**CITY OF LA VISTA
PLANNING DIVISION**

RECOMMENDATION REPORT

RE: Proposed Conditional Use Permit
Lot 1, Southport West Replat Three
Proposed Courtyard Hotel
TD² File No. 171-345.2

RE: Proposed PUD Plan Amendment
Lots 1-3, Southport West Replat Three
Proposed Hotels & Conference Center
TD² File No. 171-345.3

C101

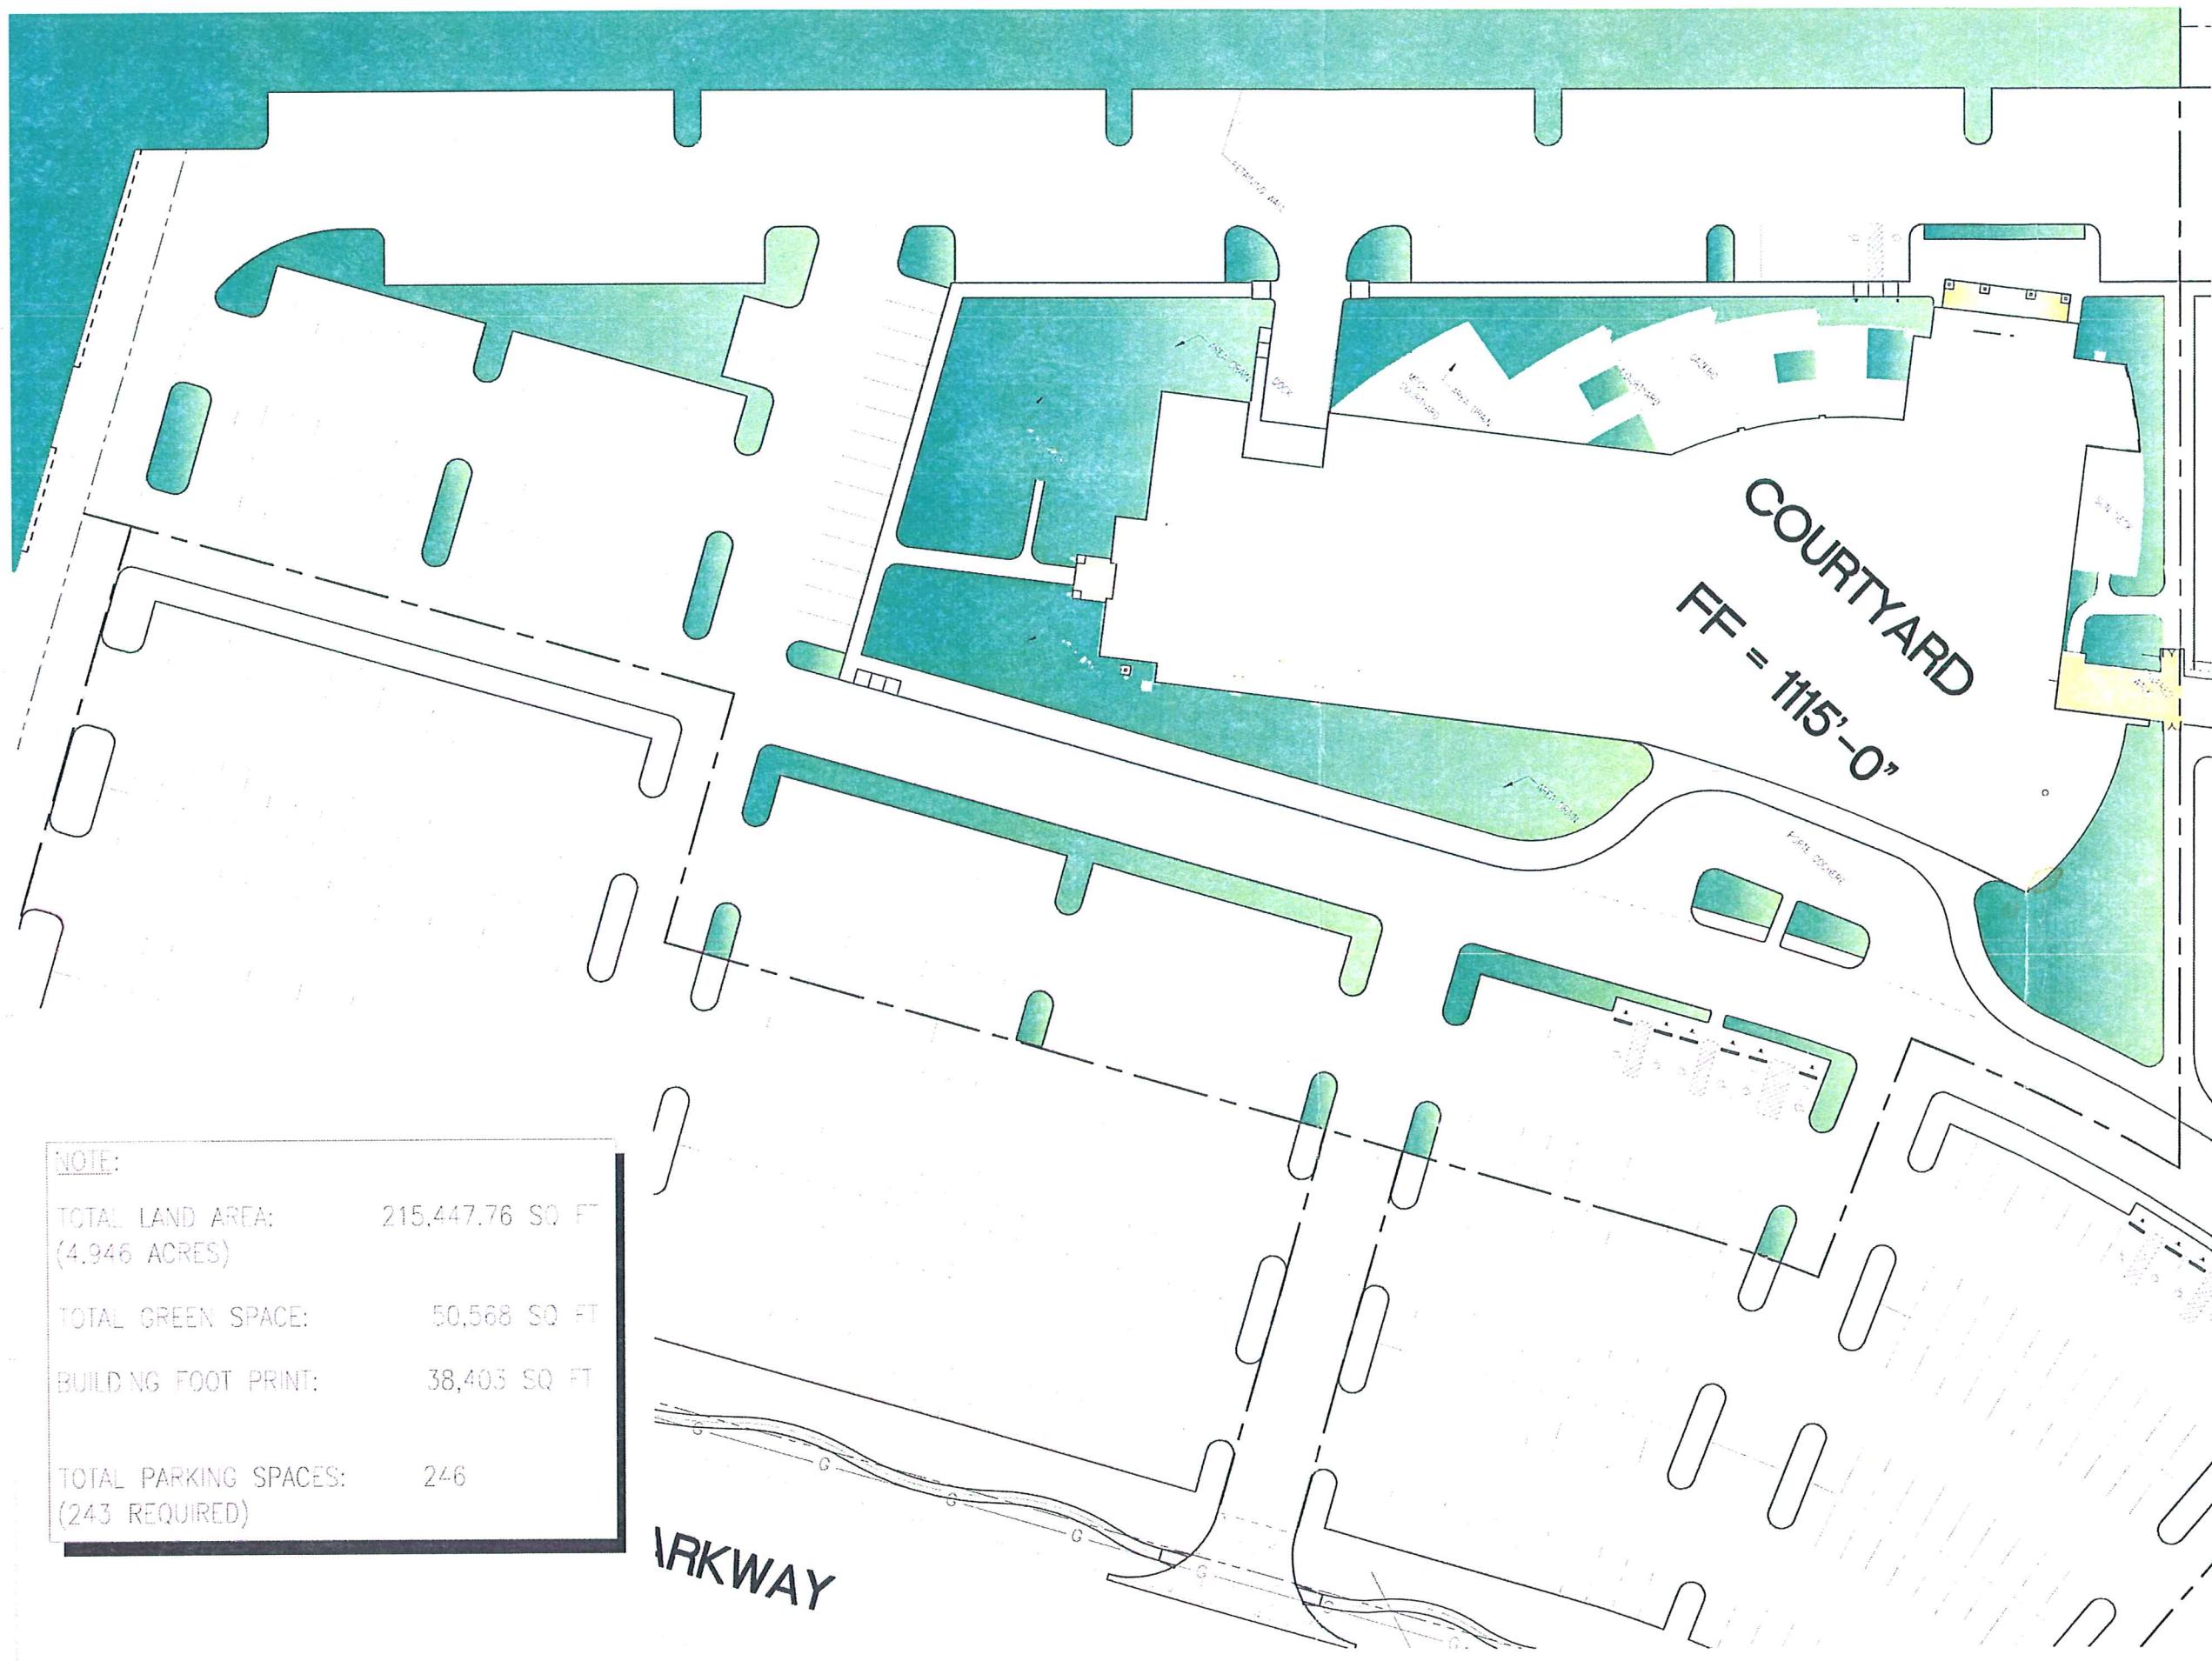
2. The PUD plan needs to address sidewalk connections from the proposed buildings to the external sidewalk system. The plan shows only one sidewalk connection from the conference center main entrance. I recommend consideration of secondary sidewalk connections at two other locations to accommodate probable pedestrian movements.

3. The PUD plan needs to show the location of the existing driveways into the City parking lot on the southerly side of Westport Parkway to demonstrate coordination of the proposed entrances with these existing entrances. What is labeled as Cabela's parking lot should be changed to say "City Parking Lot".

4. The distances from the proposed parking lot perimeters to the right of way lines along Westport Parkway and I-80 should be identified on the PUD plan to demonstrate compliance with the greenspace requirements in the Southport West Design Guidelines.

5. The Southport West Design Guidelines require 10 feet of landscaping along interior lot lines. At the westerly perimeter of the PUD Plan there is a shared access driveway centered on the lot line, which makes it impossible to place the 10 feet of greenspace along the property line. I recommend that the row of islands adjacent to this shared drive contain an amount of greenspace equivalent to the 10 feet strip that would have been required along the property line. The PUD amendment may need to address this situation.

6. There is a data table on the PUD plan that shows composite open space on the combined three lots to be 22.9 percent. This is less than the 25 percent required in the latest PUD amendment and the Southport West Design Guidelines. The applicant needs to identify whether they will revise the plan to meet this requirement or whether they are requesting an amendment to the PUD to allow a lower percentage.

7. The applicant needs to provide information on the amount of parking lot interior green space. The latest PUD amendment and the Southport West Design Guidelines require 10 percent. It is unknown whether the proposed plan complies with this requirement.

8. The PUD plan contains information on proposed and required parking. This data shows 1990 stalls required and 953 stalls provided. The City undertook the creation of a City Parking Lot in order to provide for shared uses between developments in Southport and to allow for peak event overflow from one facility or use to another. The applicable zoning regulation requirements are one space per unit for the hotels and one space for four persons of licensed capacity in places of assembly like the conference center. For retail, the requirement is 4.5 spaces per 1,000 square feet of gross floor area. The largest variable in this instance is the capacity of the conference center. It appears the data table on the submitted PUD plan is based on the Code capacity of the conference center being 6,000 persons. The applicant should confirm that this is what was used to show the 1500 stall requirement for the conference center. Previous communications with the applicant and the manager of the facility have indicated much lower capacities or parking requirements are expected for the conference center. Perhaps it would be helpful to review what is known about the composite parking for Cabela's, the hotels and the conference center so far:
